**Consultation Response from KC,
Trees****2023/91513 25, Bishops Way, Meltham, Holmfirth, HD9 4BW****Erection of two storey side extension****Date Responded:16/08/23****Responding Officer:M Moss****Responding Ref:50/95**

Layout of the scheme was as follows:

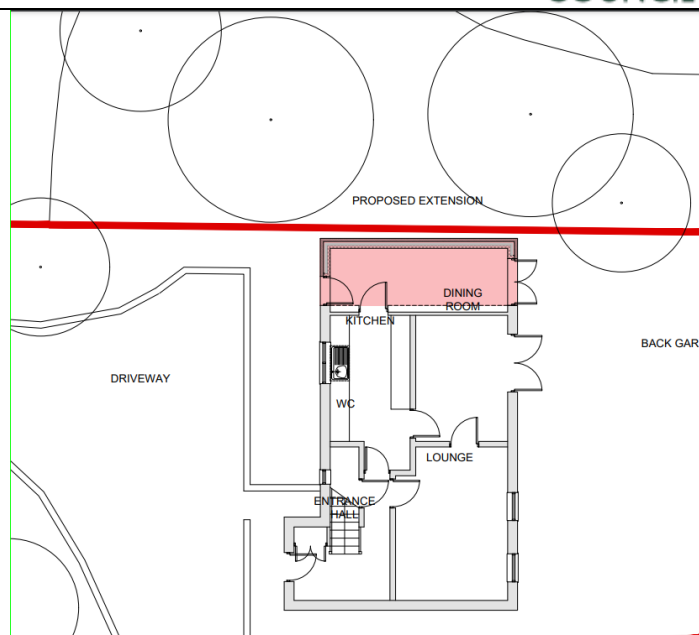
The proposed development would be located within close proximity to significant trees of substantial amenity value and those which are protected by a Tree Preservation Order. The development would lead to significant pressure to those trees for pruning and would have a direct conflict with the root protection and canopy area of these significant trees leading to a harmful impact of the development to the viability and longevity of the significant amenity and protected trees. To permit the development would be contrary to Policies LP24(i) and LP33 of the Kirklees Local Plan, policy within Chapter 12 and 15 of the National Planning Policy Framework and Key Design Principles 12 and 13 of the House Extensions and Alterations SPD.

Application 2023/91513 – Resubmission which is currently pending determination

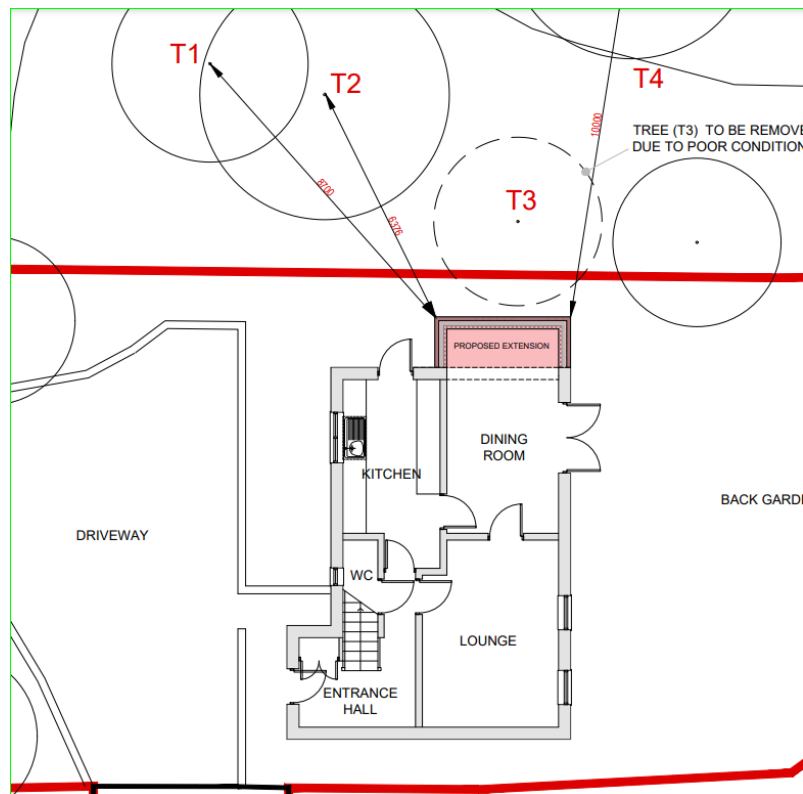
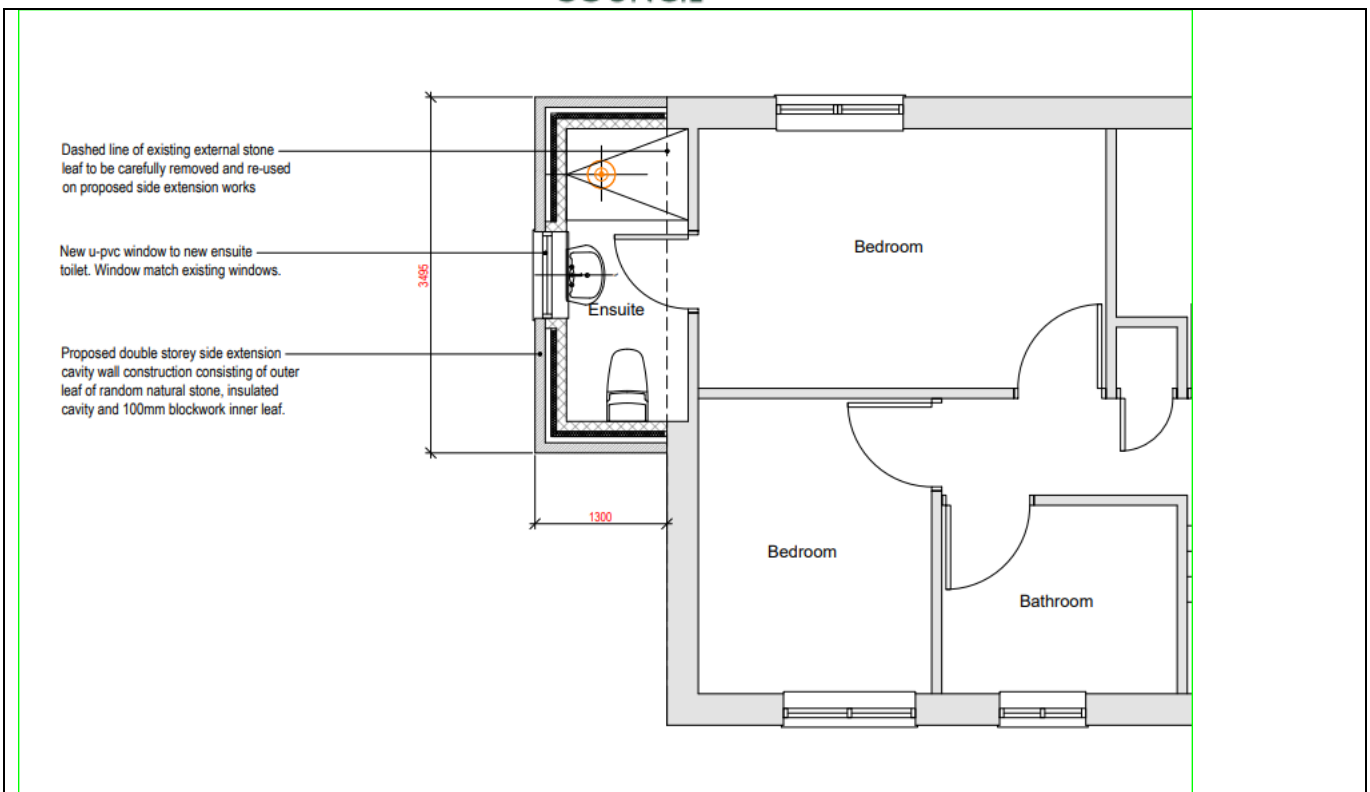
The scheme has been revised, with a reduced scale of development proposed, as set out in the following:-

As discussed, the proposal will incorporate the removal of one tree (tree 3 on the above plan).

Given the amended scheme, in terms of being further from the boundary, and fact the only opening proposed would serve a bathroom, the previous reason for refusal appears to have been suitably addressed.

Can you confirm you are in agreement with this assessment of the revised scheme?

Yes, I agree that this reduction of the proposed extension and removal of the double opening is an improved design that will create less of an ongoing conflict with the adjacent tree line and therefore is more acceptable from a trees point of view.
